# HARTING Product Change Notification

**PCN/18/006/C+N**

**Product range:** DC2 / PushPull, RJ, ix & har-port

**Title:** Minor change of DIN rail outlet for RJ45 Keystone jacks - External

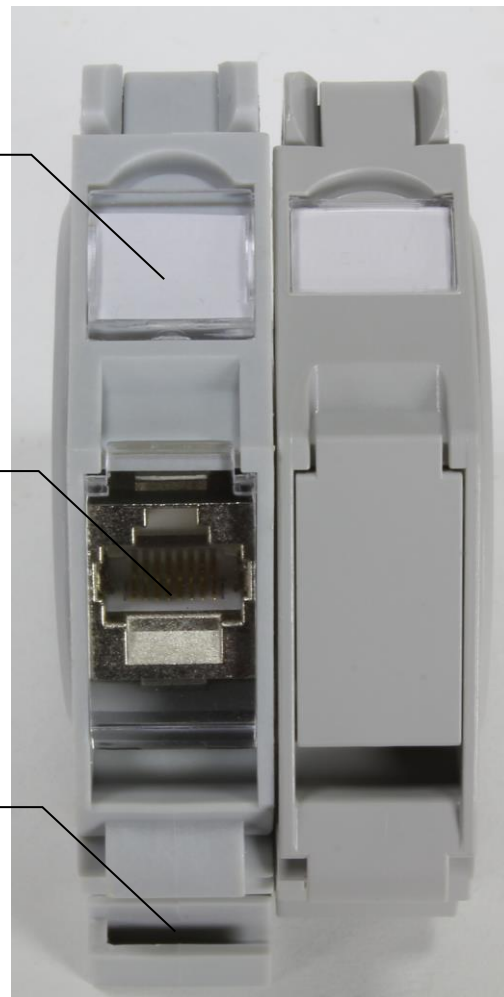
The plastic molding tools needed to be replaced and we use this task to improve some points of the DIN rail outlet design. See picture with the details below.

NEW: Bigger marking area

NEW: Transparent cover

NEW: Improved unlocking area

New desing

Old design

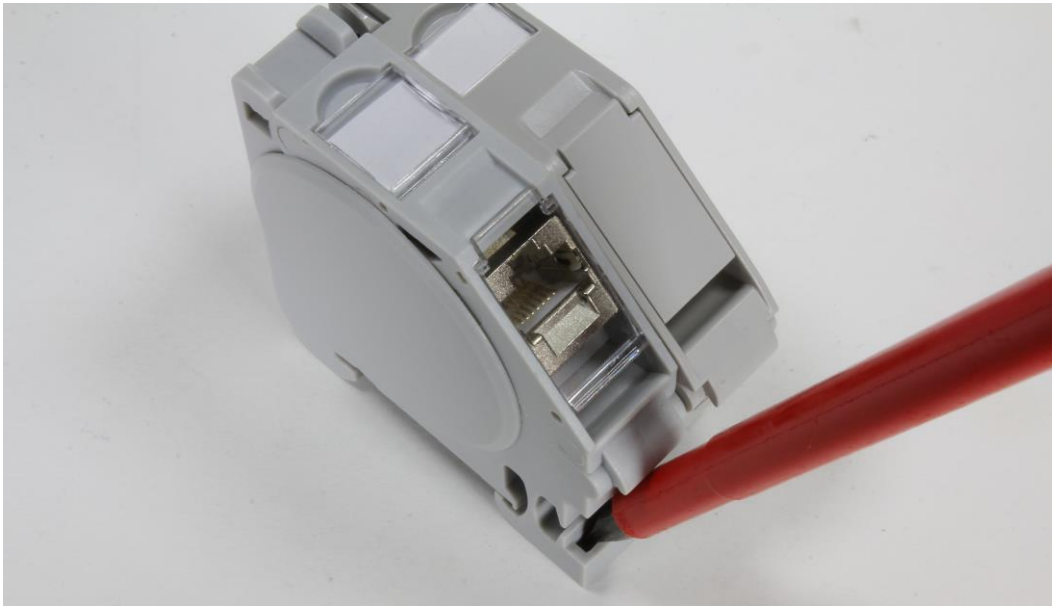
At this picture the improved unlocking area is shown in function with a screw driver to remove the DIN rail outlets from the DIN rail more easily compared to the old design.

All main dimensions are identical as the old design and in this way, we don't have any negative influence to any application.
